Bechtel Power Corporation

Subject: NUREG-0814 Draft Report for Comment, Dated
August, 1981 - Methodology for Evaluation
of Emergency Response Facilities

Bechtel has reviewed the subject Draft NUREG-0814 and offers the following comments.

FIGURE 2.1

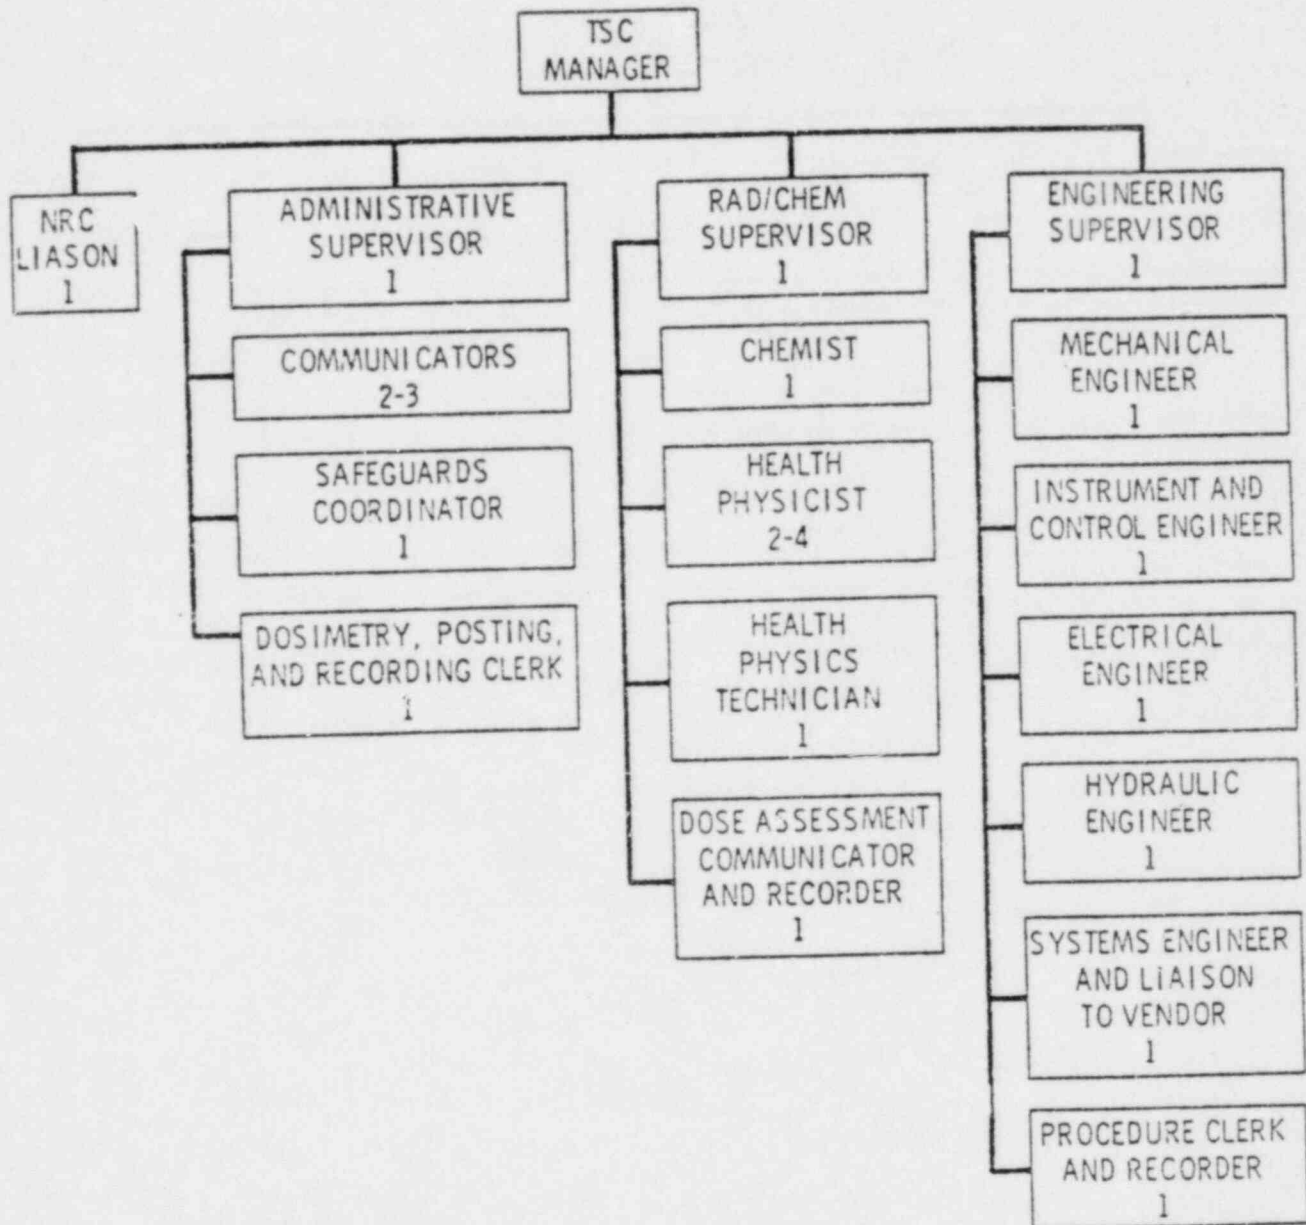
COMMENT:

No nuclear engineer is shown. Staffing could vary depending on event.

FIGURE 5.2

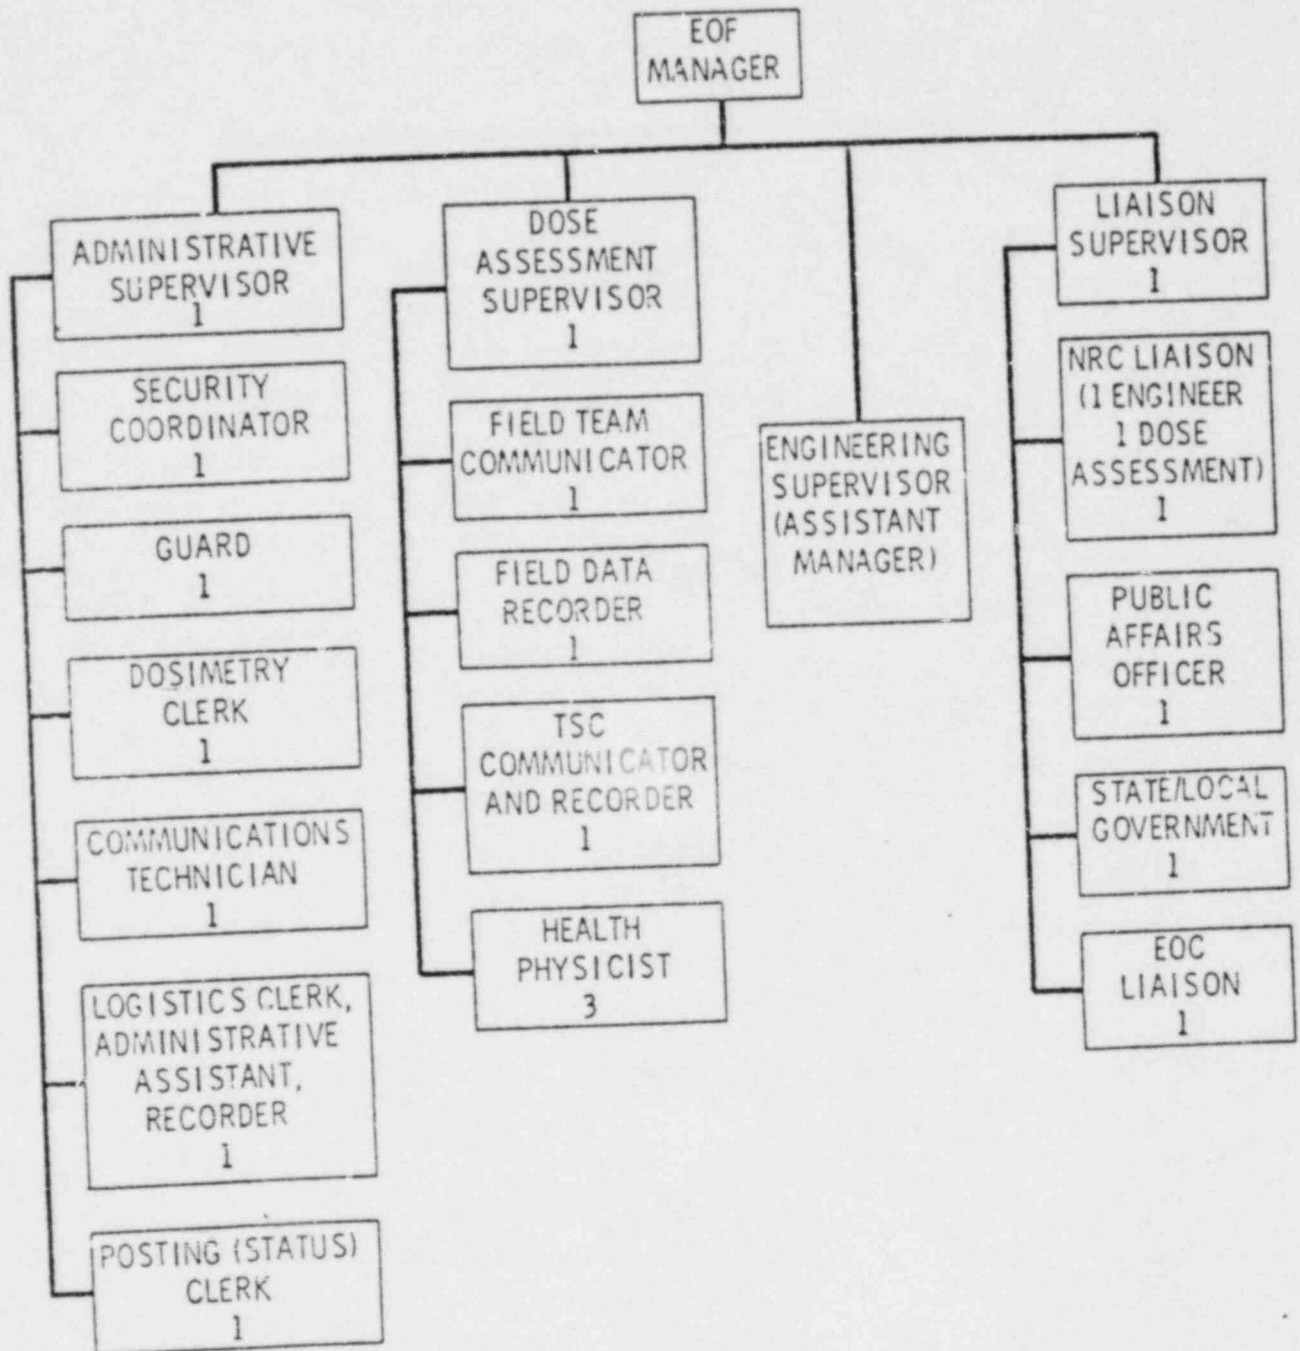
COMMENT:

Reduce the number of health physicist and add a meteorologist
